## **Amendment No. 1 to Tender No. SGI2505P17 dated 19/09/2016**

**PROPOSED SLD OF THE SYSTEM**

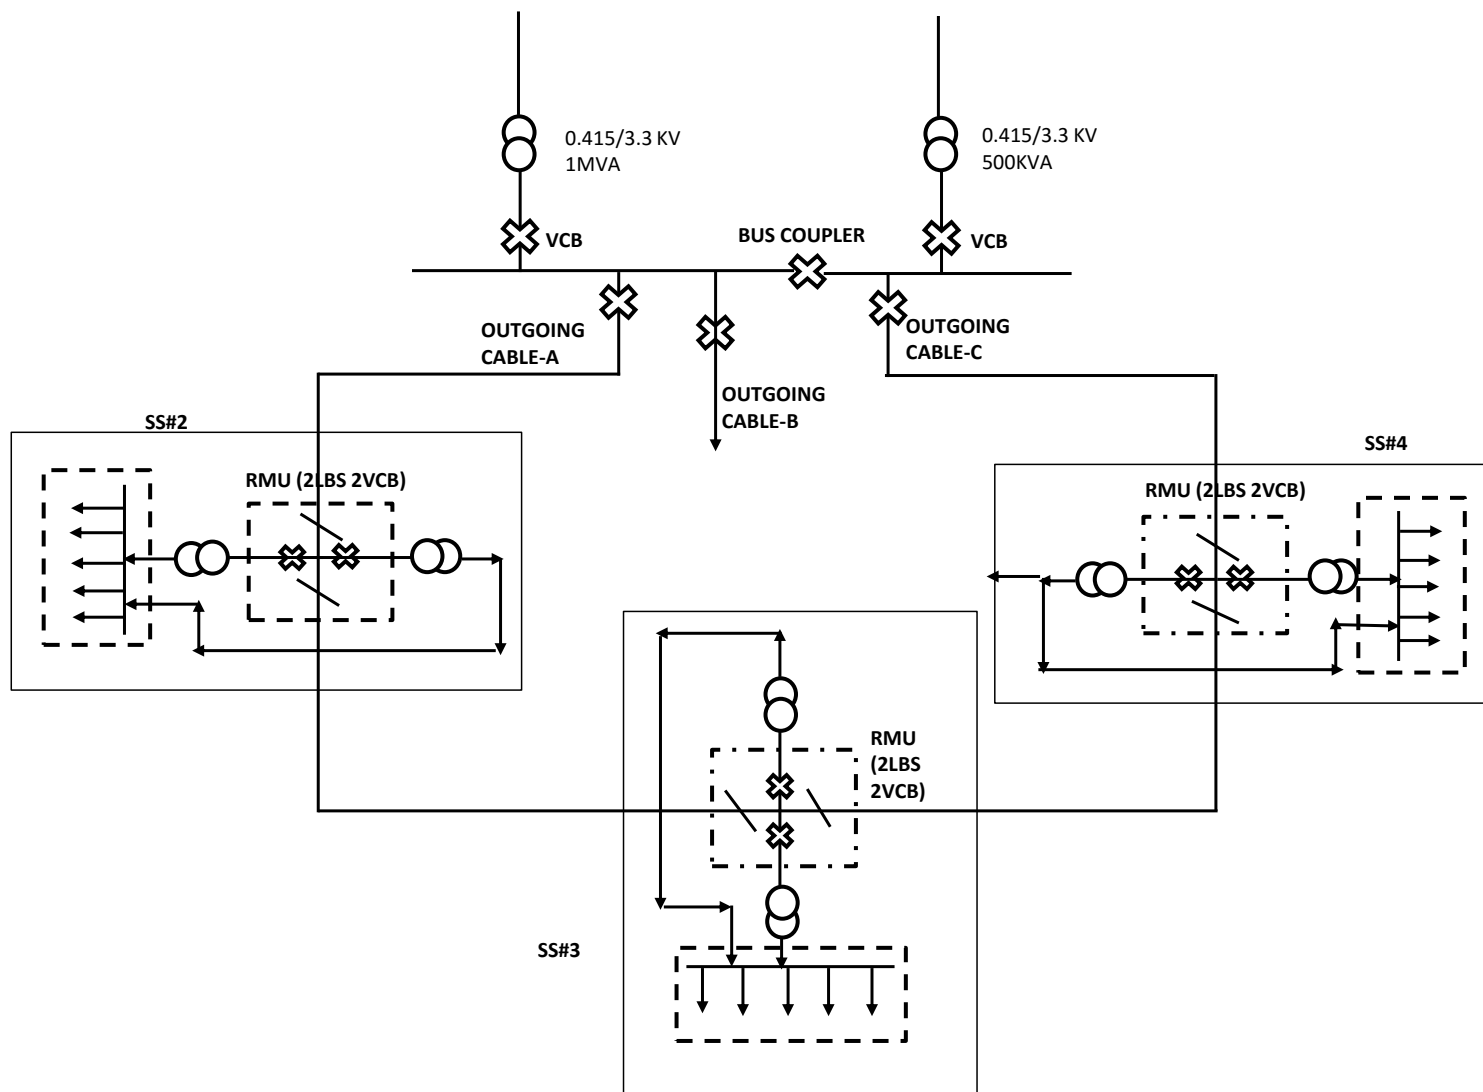
during execution of jobs requiring prolong shutdown.	
11.0		Attached drawings to be uploaded as Amendment to tender.
12.0	<b>BEC/ BRC clause C, (iii) The Bank Guarantee towards Bid Security shall be valid for 90 days from the Bid Validity as mentioned in Sl. No. (i) above</b>	No change
13.0	<b>Item no. 10 and 20 . Pre-despatch Inspection</b>	To include clause in Pre-despatch inspection that “ charges related to to & fro, fooding , lodging of OIL personnel is not to be borne by bidder.”
